Comments in magenta red provided by
Slantern@auroragov.org (Drainage)

Preliminary Drainage Report For Foundry Filing No. 1

Aurora Water Drainage

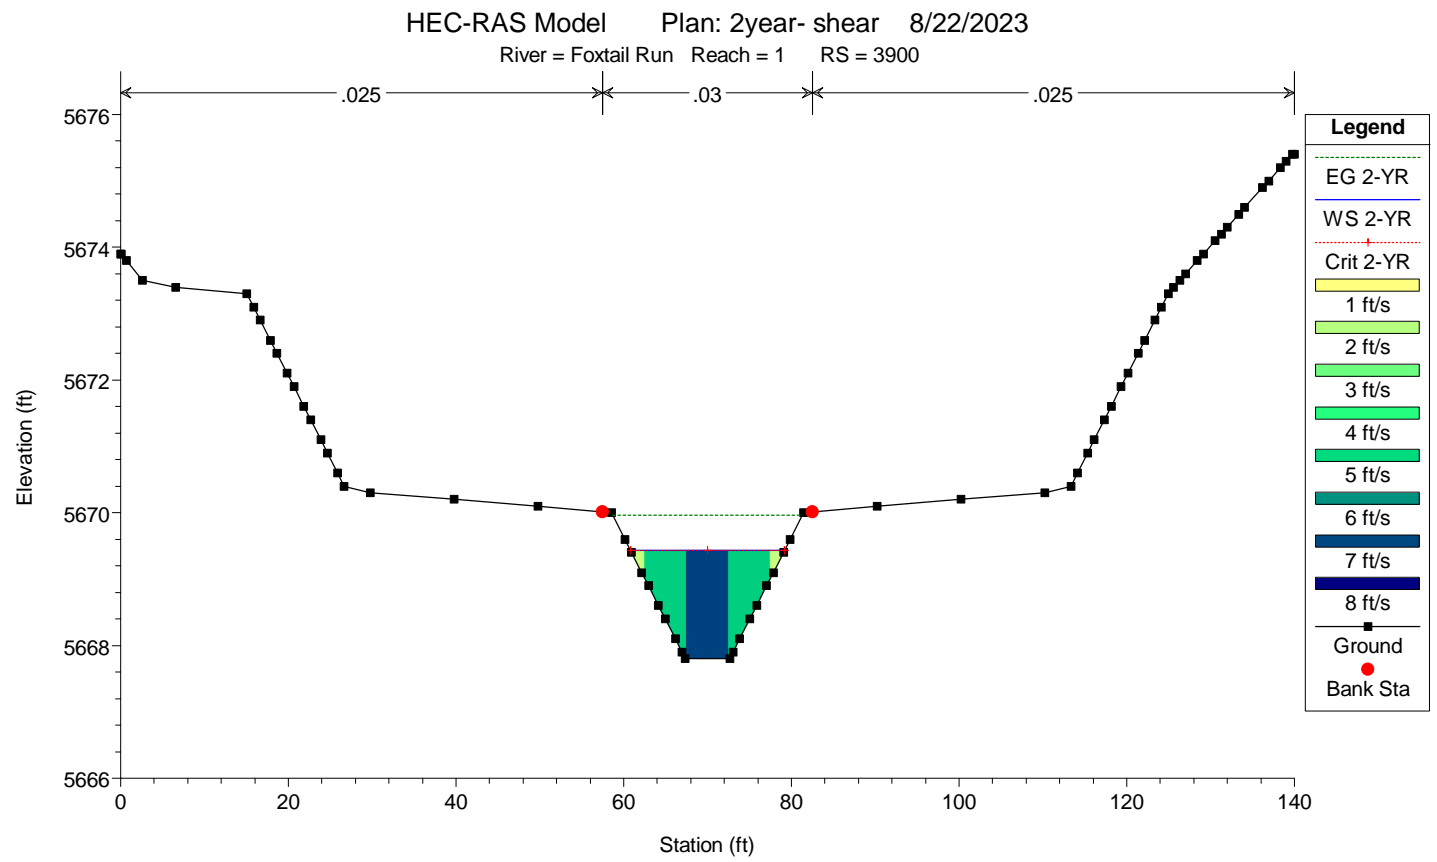
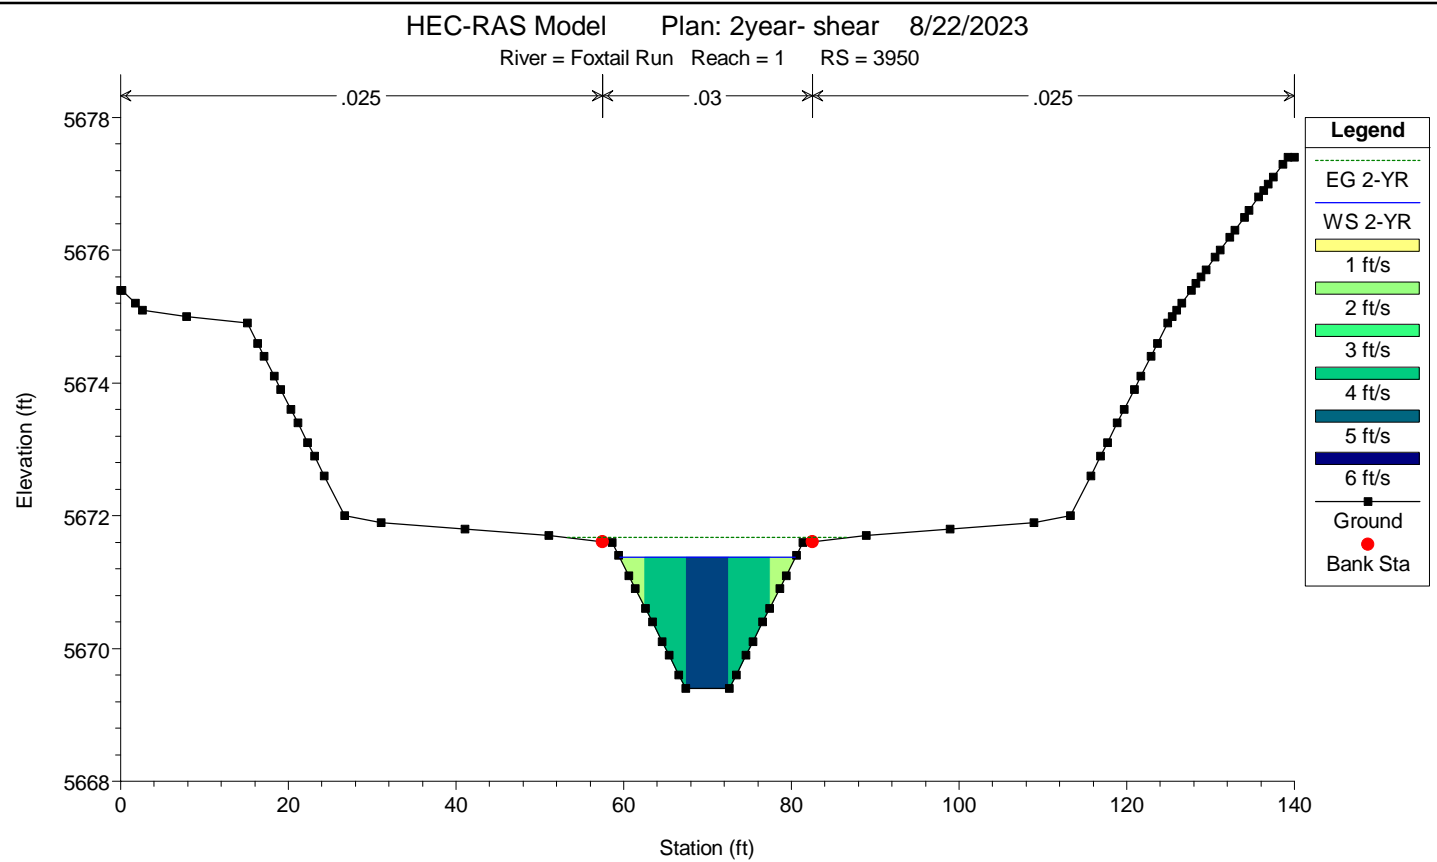
The values for the upstream “reach 2” still appear to be too low to represent the cascading boulder drops

Please provide justification for 0.04 used on the downstream cascading boulder drops. Are these based on void-filled riprap calculations or another method? See Chapter 8 and Chapter 9 of MHFD USDCM for riprap and boulder Manning’s calculations.

Ensure Manning’s value is correctly represented for hardened drops into culverts. Currently called out as sculpted concrete but could also be grouted boulders depending on aesthetic preference of development

JR ENGINEERING: Per discussion with MHFD, a Manning's n value for void-filled riprap was used within the limits of the boulder cascades. There is no specific guidance in MHFD criteria on a boulder cascade, but by using a void-filled riprap value, we can evaluate the stability of the riprap that lines the channel in these areas.

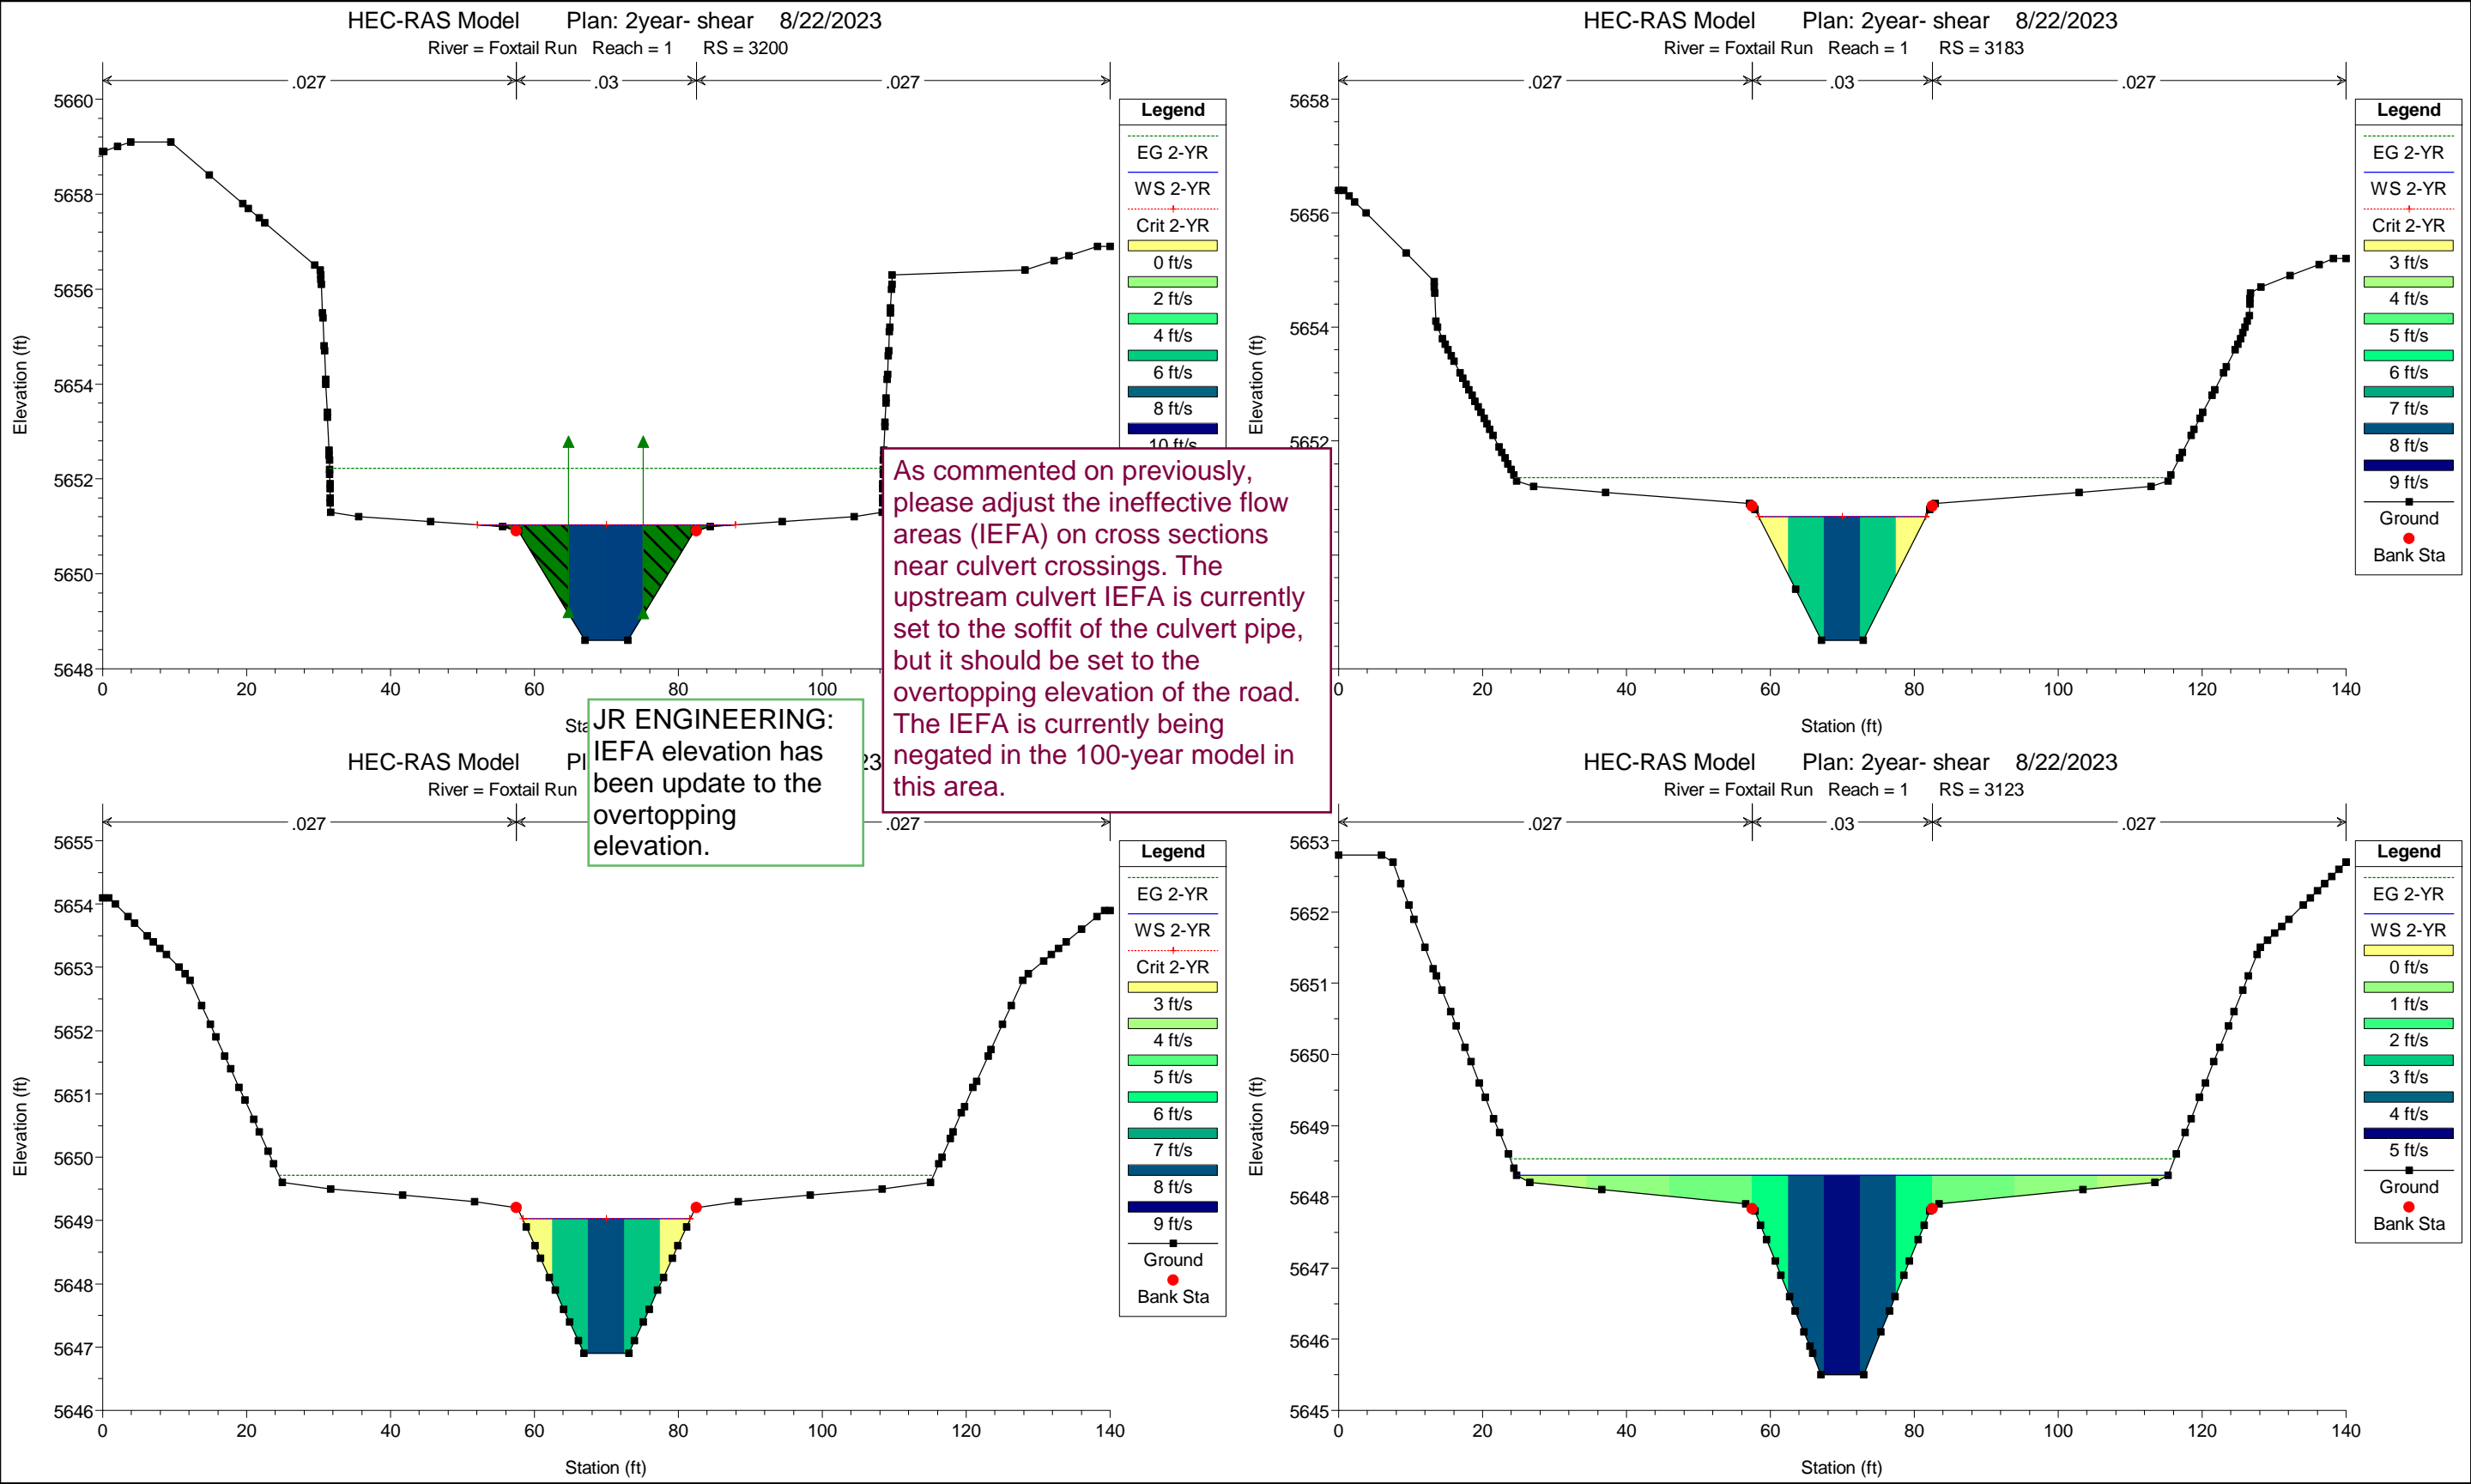
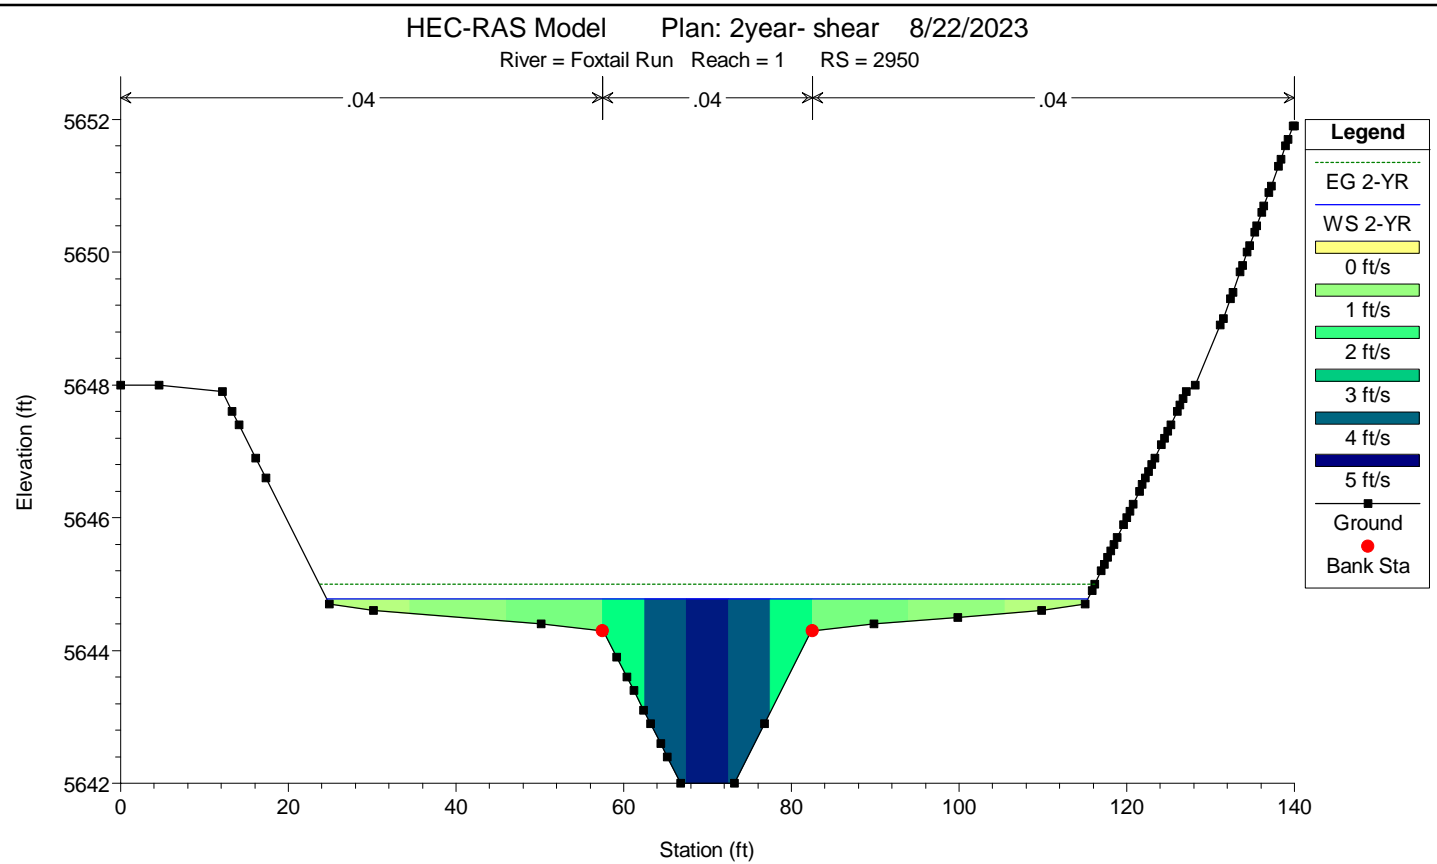
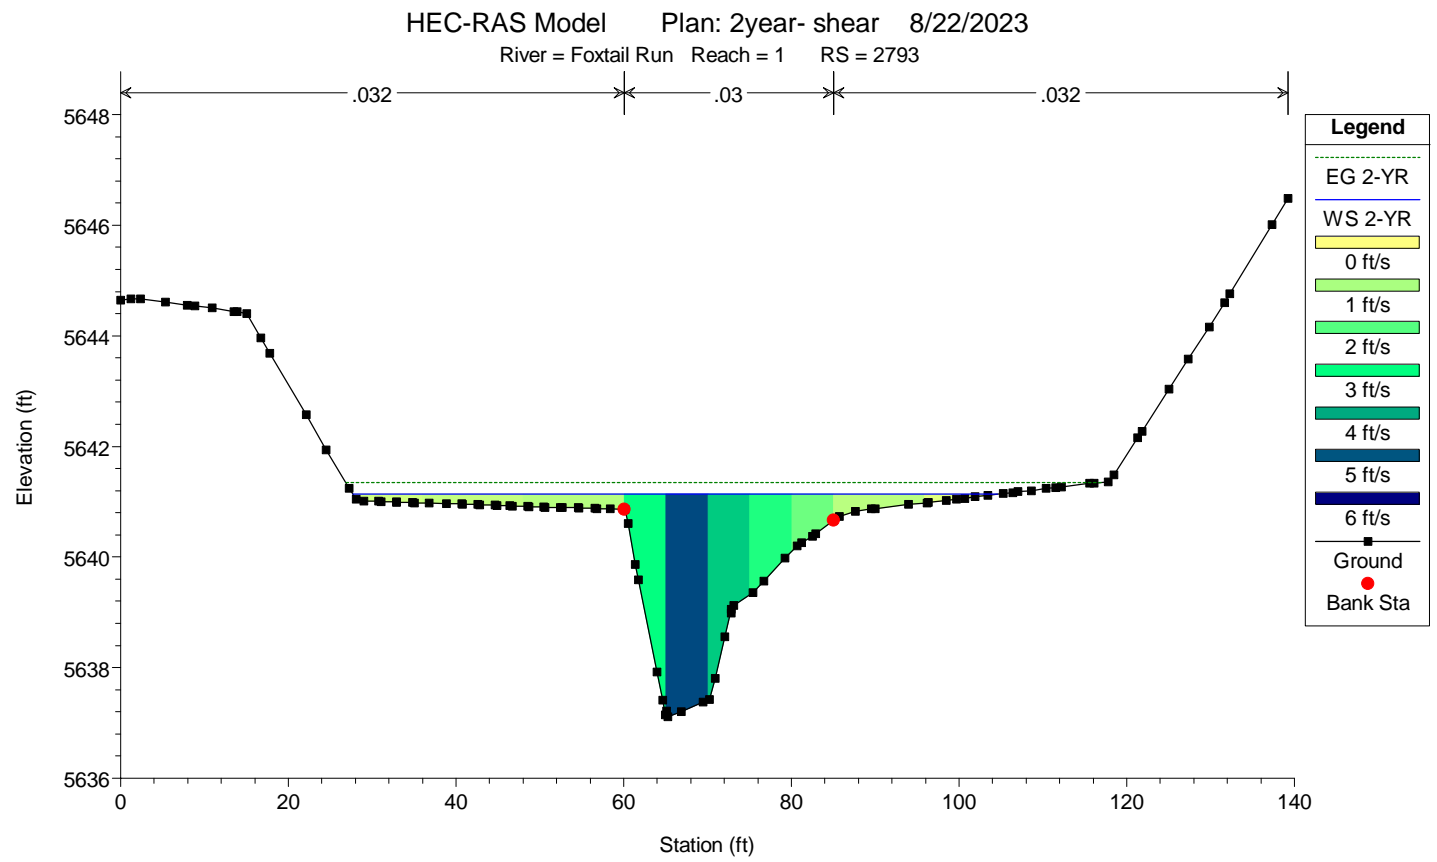
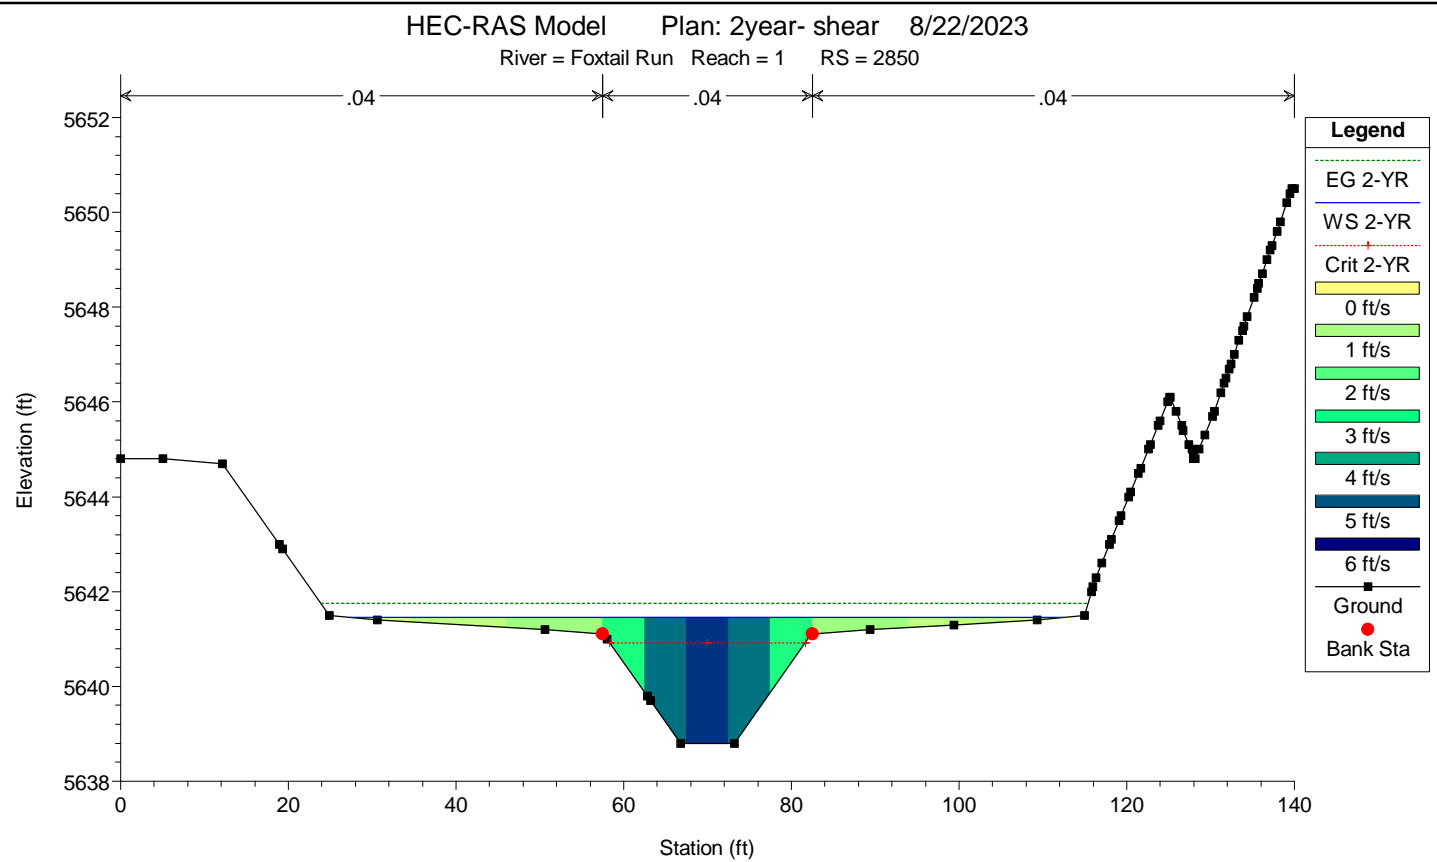
As commented on previously, please adjust the ineffective flow areas (IEFA) on cross sections near culvert crossings. The upstream culvert IEFA is currently set to the soffit of the culvert pipe, but it should be set to the overtopping elevation of the road. The IEFA is currently being negated in the 100-year model in this area.

JR ENGINEERING:
IEFA elevation has been update to the overtopping elevation.
